**National Pollutant Discharge Elimination System (NPDES) Permit for
US Silver Corporation- Coeur and Galena Mines and Mills
NPDES Permit No. ID-0000027**

Response to Comments

May 23, 2007

U.S. Environmental Protection Agency, Region 10
1200 Sixth Avenue
Seattle, WA 98101

Figure D-1: Comparison of Chronic Cd SSC to outfall 001 Cd Conc upon Mixing

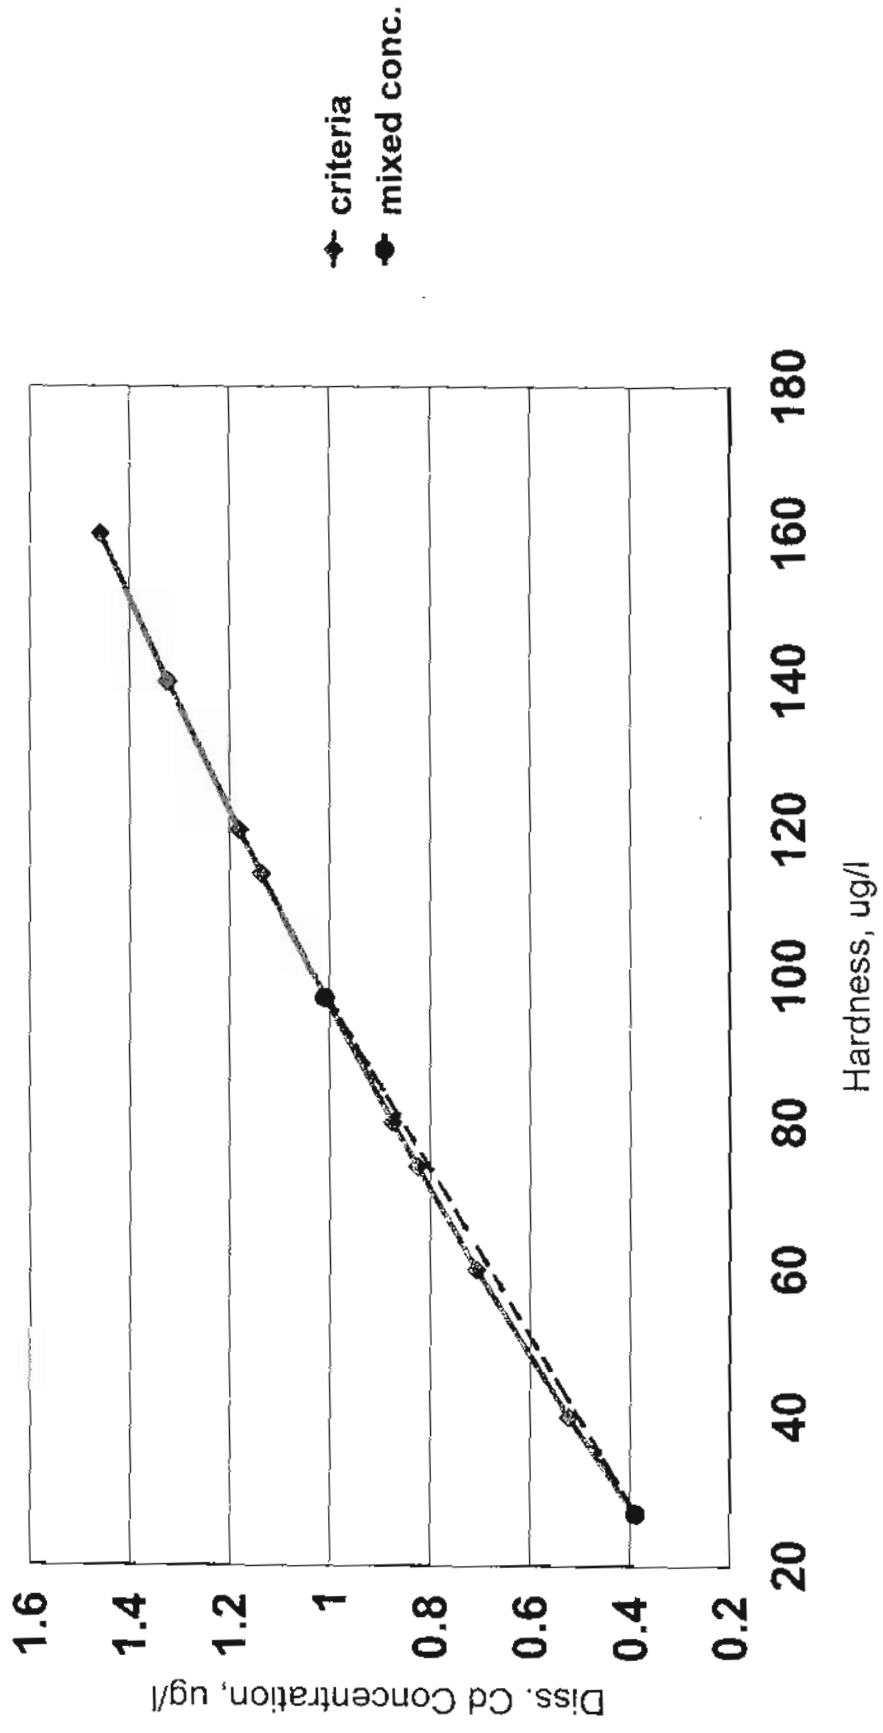
For cadmium, lead, and zinc, the straight lines representing the mixed effluent-receiving water concentrations are always below (less than) the chronic criteria, therefore, as the effluent discharges to and mixes with the receiving water there is never an exceedence of the criteria. Therefore, the use of effluent hardness to calculate the cadmium, lead, and zinc limits is protective of the water quality criteria.
